Your Comment on the Downtown Carpark Redevelopment project draft conditions

1 Introduction

2 Comments on Conditions

2.8 Conditions (127A), (127B), (127C), & (127D) Hotel PUDO Monitoring, Monitoring Parameters, Reporting Requirements, and Reinstatement

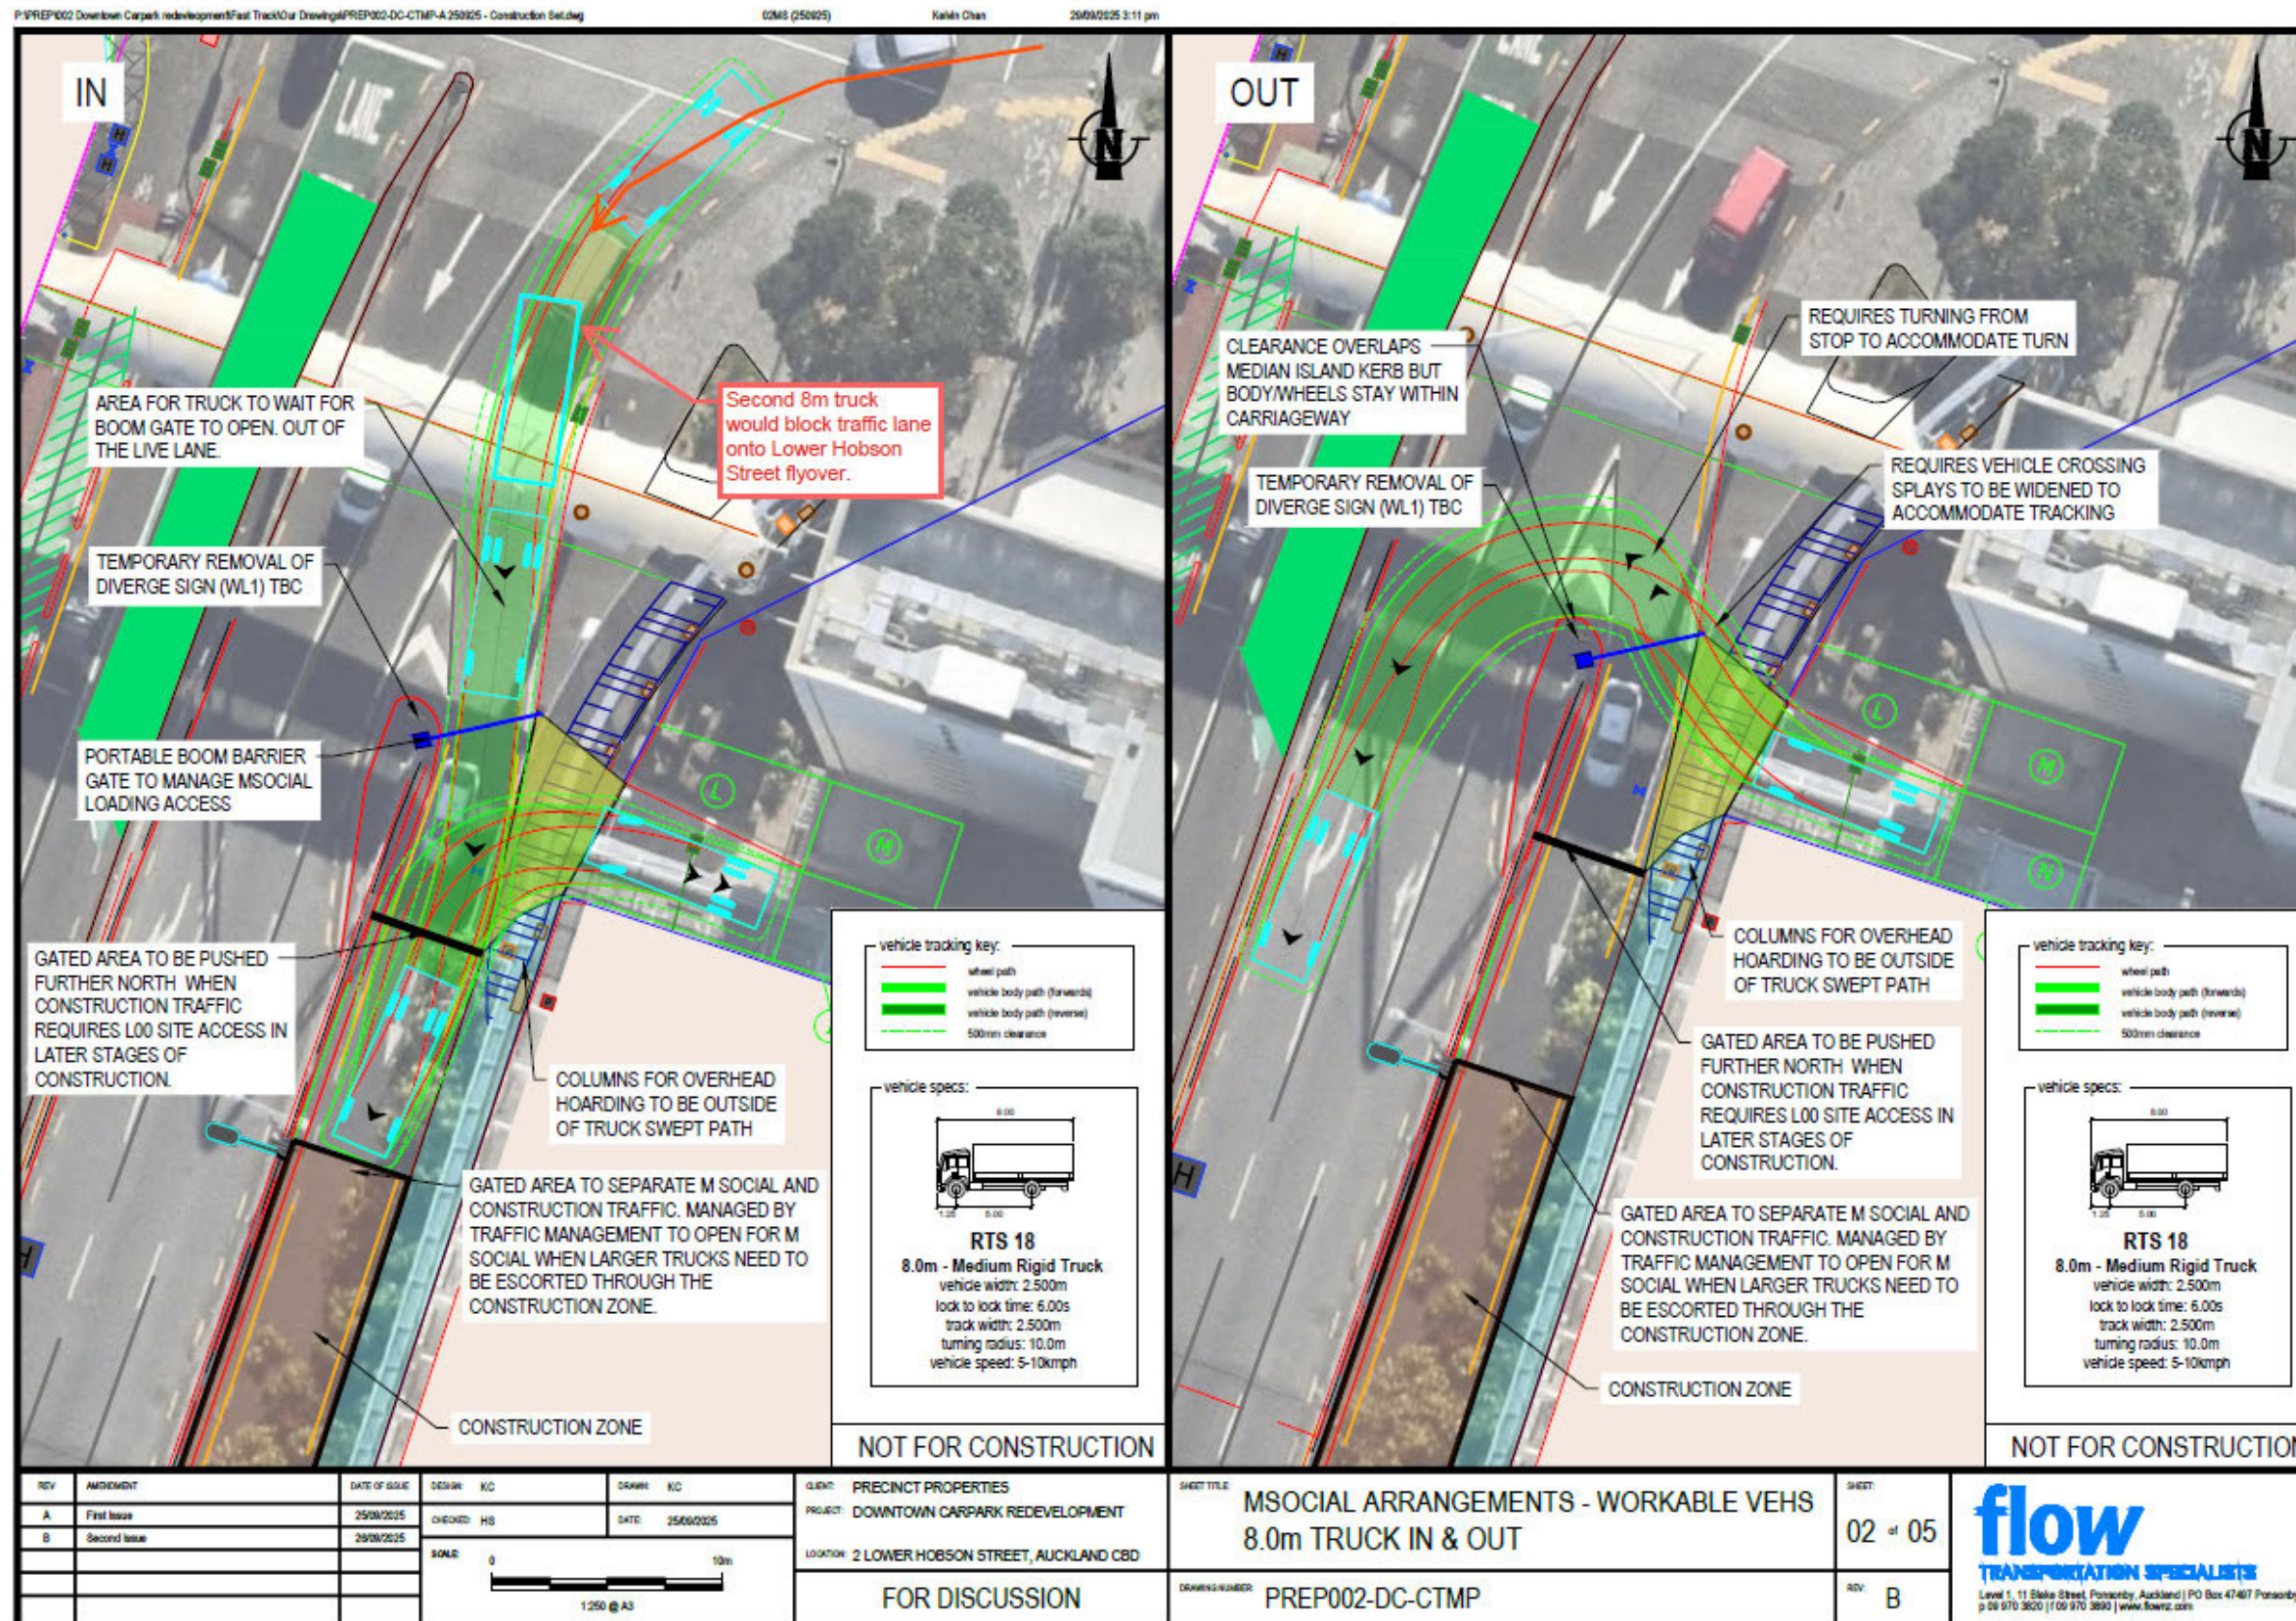
- (a) AT acknowledges the position reached by the Panel in para 433 of the draft decision. The Applicant’s position predominantly relies upon Condition (126)(h), which includes a general provision to supply a monitoring programme and management plan review in certifying the Hotel Pick Up and Drop Off Management Plan (“**HPUDOMP**”). There is no disagreement between parties relating to the need for the monitoring and review programme, which was notably endorsed by Hughes Transportation via the independent peer review with increased monitoring frequencies. However, the monitoring and management plan review processes are detailed within the draft HPUDOMP itself and are general and do not address all operational issues that may occur that could impact the adjacent network. AT’s detailed recommended conditions are intended to clarify the nature of “Operational

issues”, not otherwise specified within the body of the HPUDOMP, that should be assessed when the Applicant undertakes surveys of the Hotel PUDO. The draft provisions included within the HPUDOMP also do not include any reporting requirements to identify how the findings of the surveys to be undertaken will be assessed. Similarly, AT has recommended details surrounding how the survey data should be presented to inform a discussion around the need for any additional measure(s) to be implemented to achieve the objectives set out in Condition (125) of these consents. There is no equivalent mechanism proposed within the HPUDOMP that captures an exploration, and associated implementation, of any recommendations to address any concern(s) that may be identified through the monitoring of the HPUDOMP’s performance to ensure that the safety and performance of the transport network is maintained. It is considered that the provisions included in AT’s recommended Condition 127C(d) achieves this outcome.

- (b) For the avoidance of doubt, AT remain of the view that a contingency condition should be included in the event that the use of the Hotel ceases to exist in order to remove the Hotel PUDO and reinstate the adjacent footpath, and kerb and channel. For the reasons outlined within para 10.8 of AT’s memorandum dated 29th April 2026, the use of the Hotel PUDO has solely been assessed based on any trips associated with the use of the hotel and management measures that are available associated with the hotel’s operation. A different activity may generate fundamentally different trips by comparison to the use of the hotel, which would unlikely have the same types of management measures available such as the likes of the valet / concierge service to be able to turnaround any user from arriving to or departing from the Hotel PUDO, that could materially impact the degree of queuing that may occur with the constrained dimensions of the Hotel PUDO.
